REVISION			CITY OF RIVERSIDE, CALIFORNIA
MARK	DATE	DESCRIPTION	DEPARTMENT OF PUBLIC WORKS
1	10-29-64	ADDED 12" WATER LINE, ENID. AND SEWERS. Bob S. [signature] AKD	STORM DRAIN PLAN & PROFILE
2	3-19-65	REVISED TO SHOW SCHOOL EXTENSION "AS BUILT" & VARIATION NOTE - ENID. Bob S. [signature] AKD	COLLETT AVENUE TRACT No. 2551
3	3-31-65	ADDED 8"C.F. @ CATCH BASIN & ENID. Bob S. [signature] AKD

DWG. No. 62-229-D

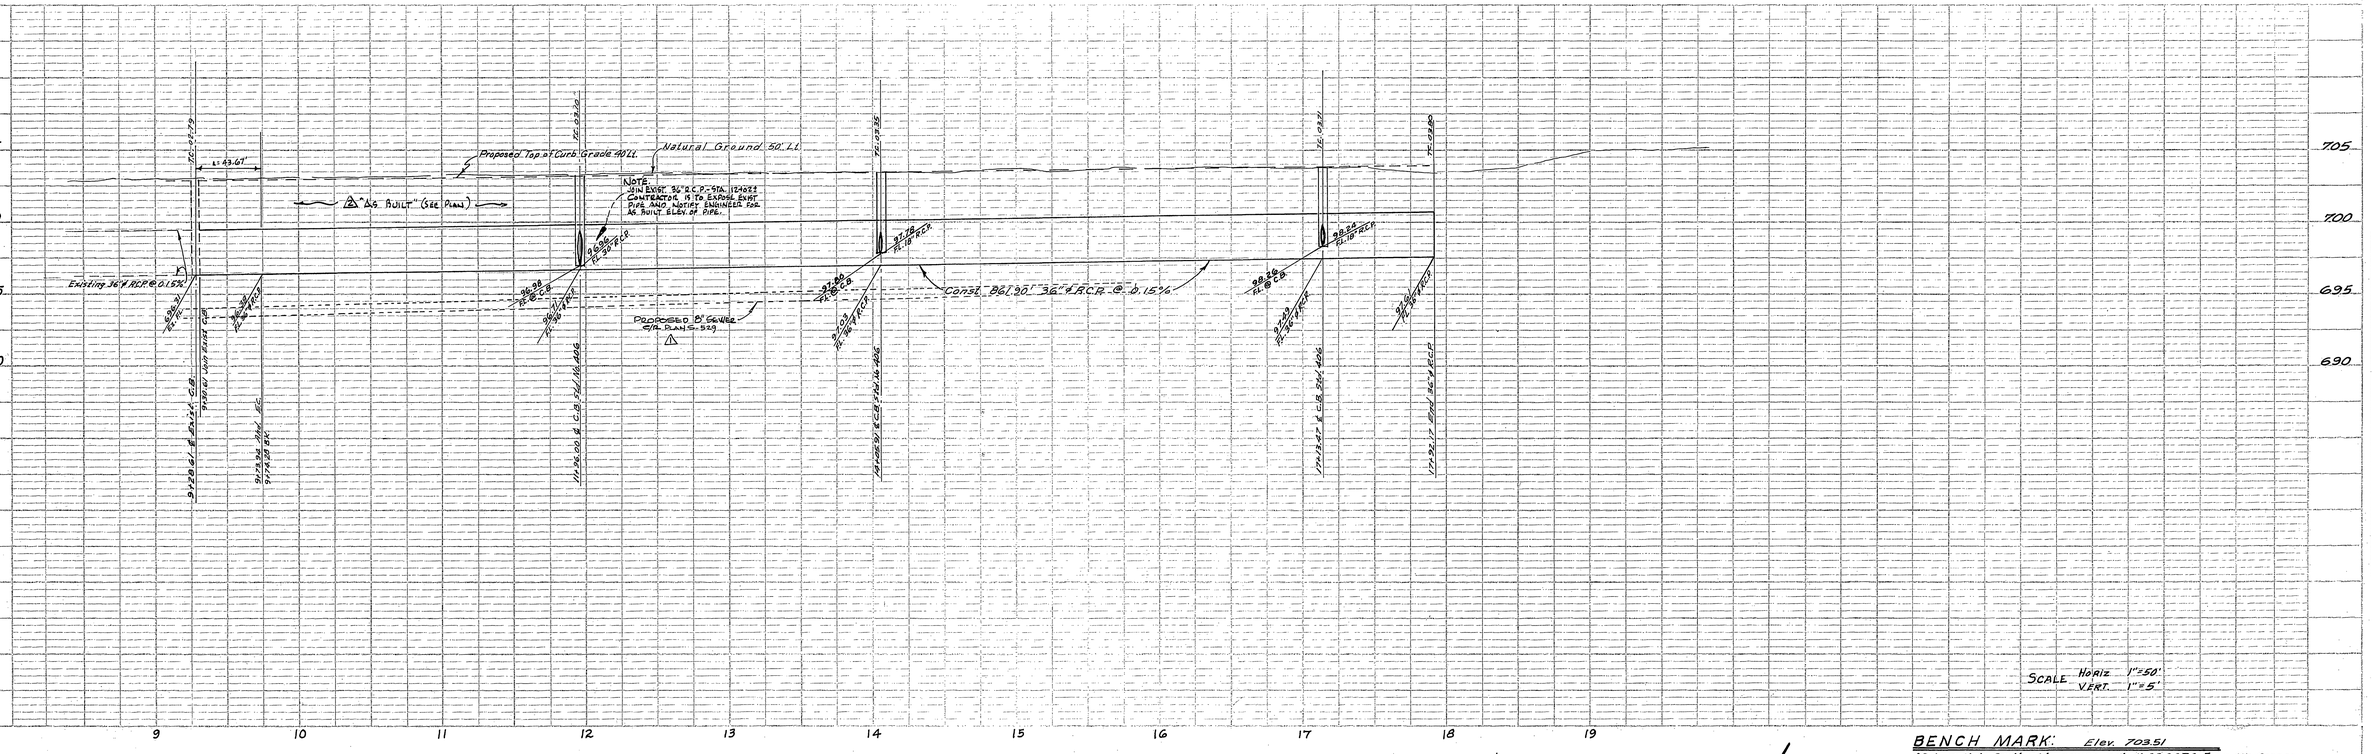
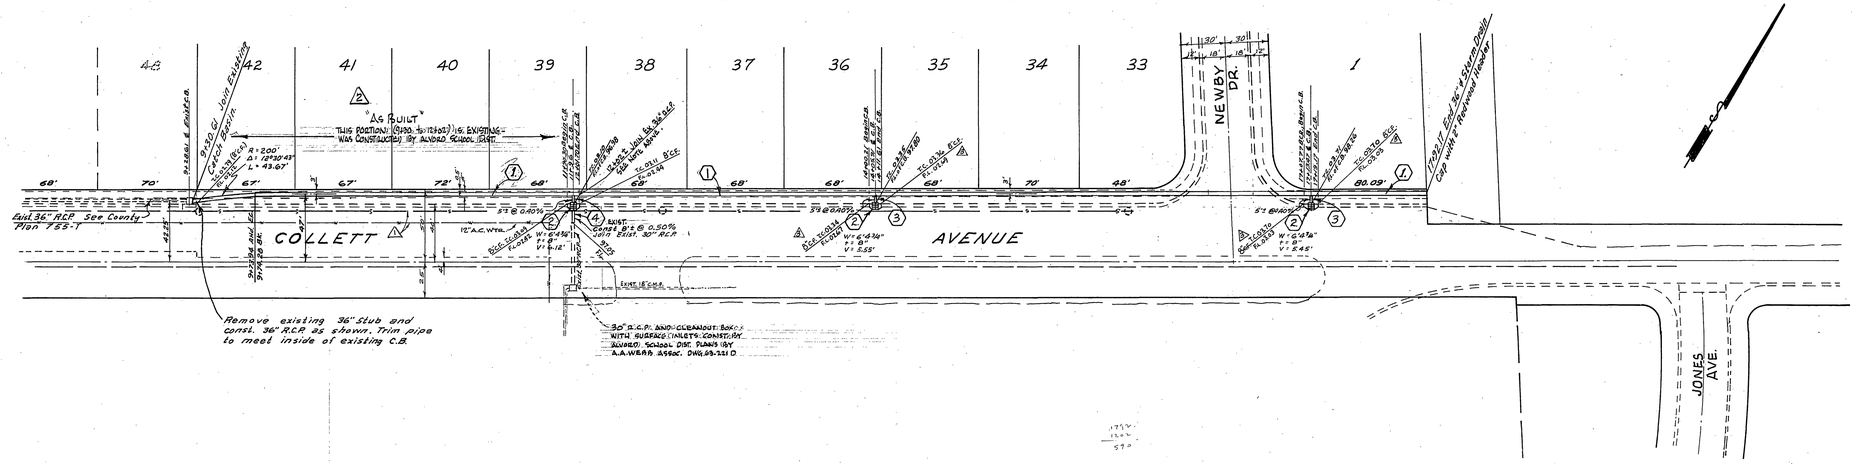
As built 36" R.C.P. ~~Alternate - no joint pipe~~	862 L.F.
36"ø R.C.P. (Alternate - no joint pipe)	862 L.F.
Catch Basin Type 4 Standard No. 406 (with 2 grates) (8"C.F. / 9½" AT OPENING)	2 3 Ea.
18"ø R.C.P.	10 L.F.
30"ø R.C.P.	13 L.F.

1. As built ~~Const.~~ 36"ø R.C.P. (~~Alternate - no joint pipe~~) 2000 D, Bedding Class II
2. Const. Catch Basin Type 4 Standard No. 406 (TO MEET 8"C.F. — 9½" EAGE AT OPENING)
3. Const. 18"ø R.C.P., 2000 D, Bedding Class II
4. Const. 30"ø R.C.P., 2000 D, Bedding Class II
